Report: TAB Report
Function: Test, Adjust, & Balance
Date: 09/04/2025
Completed By: National TAB

PROJECT
08-25-25 CAVA DANBURY, CT

Project: 08-25-25 CAVA DANBURY, CT

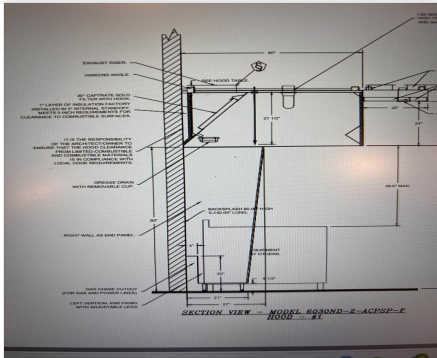
Issue Name : HD1: Gap Next to Wall
Description : Small gap between hood and well. Recommend filling.
Created By : National TAB **Assigned To :** National TAB - Dan Hertenstein
Status : Open
Priority : Low **Asset Tag :**
Originated Date : 08/25/2025 - Ryan Smith - National TAB

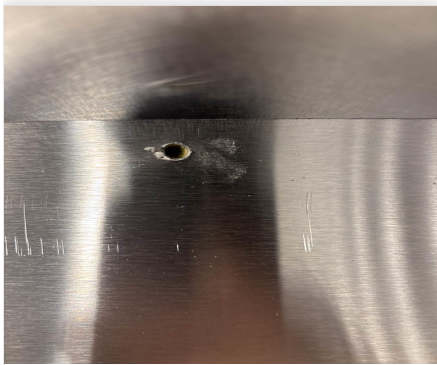
Issue Name : HD1: Not Caulked Along Wall
Description : Hood not caulked where it meets wall. Recommend caulking.
Created By : National TAB **Assigned To :** National TAB - Dan Hertenstein
Status : Open
Priority : **Medium** **Asset Tag :**
Originated Date : 08/25/2025 - Ryan Smith - National TAB

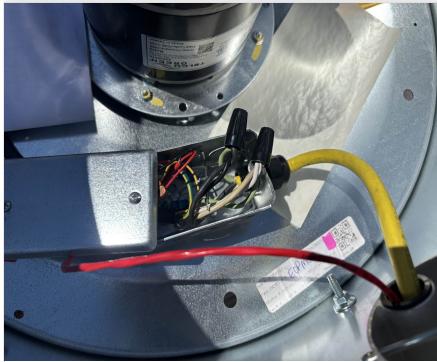
Issue Name : HD1: Small Penetration in Canopy
Description : Small penetration in hood canopy high up on right side. Recommend repairing according to manufacture directions.
Created By : National TAB **Assigned To :** National TAB - Dan Hertenstein
Status : Open
Priority : Low **Asset Tag :**
Originated Date : 08/25/2025 - Ryan Smith - National TAB

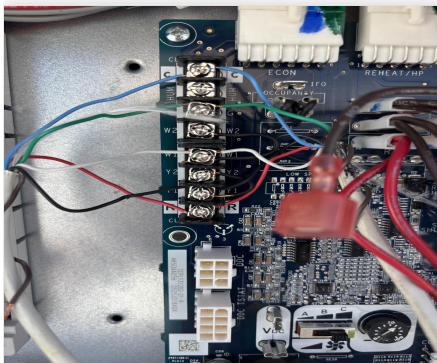
Issue Name : RTU1, RTU2: Construction Filters Still Installed
Description : Construction filters still installed in both RTUs. Recommend replacing with MERV8 filters.
Created By : National TAB **Assigned To :** National TAB - Dan Hertenstein
Status : Open
Priority : Medium **Asset Tag :**
Originated Date : 08/25/2025 - Ryan Smith - National TAB

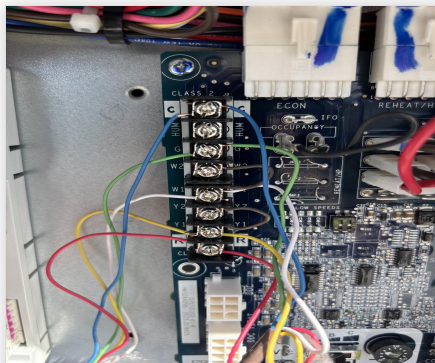
Issue Name : RTU1, RTU2: Controller Wiring Incorrect
Description : Controllers in RTUs are wired incorrectly. Y1 is jumped to Y2 and W1 is jumped to W2. Also, thermostats do not send occupancy signal to correct terminal on board, only toggling fan mode instead.
Created By : National TAB **Assigned To :** National TAB - Dan Hertenstein
Status : Open
Priority : Low **Asset Tag :**
Originated Date : 08/27/2025 - Ryan Smith - National TAB

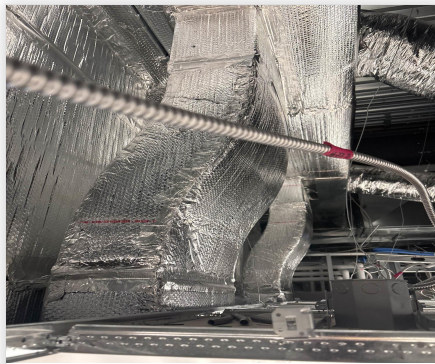
Issue Name : RTU1-1: No Dampers in ACPSP
Description : No dampers in ACPSP. Unable to adjust kitchen diffusers.
Created By : National TAB **Assigned To :** National TAB - Dan Hertenstein
Status : Open
Priority : High **Asset Tag :**
Originated Date : 08/27/2025 - Ryan Smith - National TAB

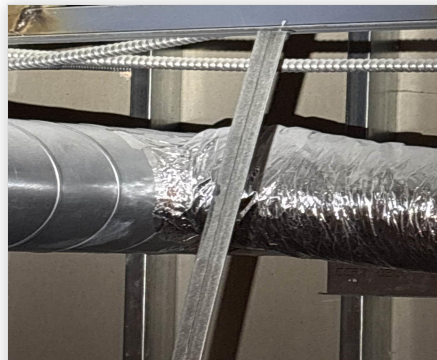
Issue Name : RTU2-10,12: No Dampers in Bathroom Supply Diffusers
Description : Bathroom supply diffusers do not have dampers. Unable to adjust.
Created By : National TAB **Assigned To :** National TAB - Dan Hertenstein
Status : Open
Priority : Low **Asset Tag :**
Originated Date : 08/27/2025 - Ryan Smith - National TAB

Asset: RTU1

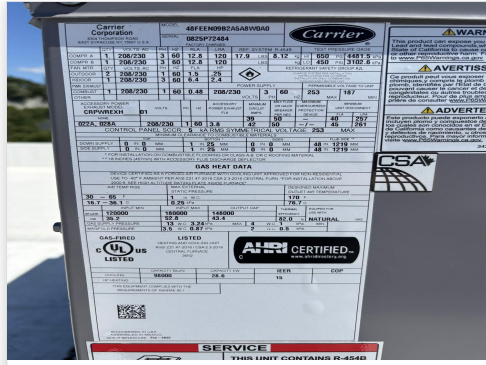
Notes:
ACPSP does not have dampers. Not able to adjust diffusers. Only balanced total airflow on entire unit.

Asset: RTU2

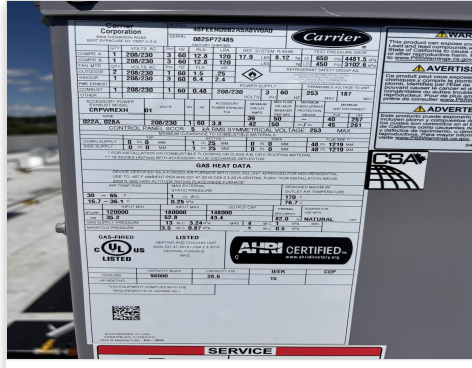
Balanced total flow only because dining area diffusers were not accessible.

No dampers in bathrooms.
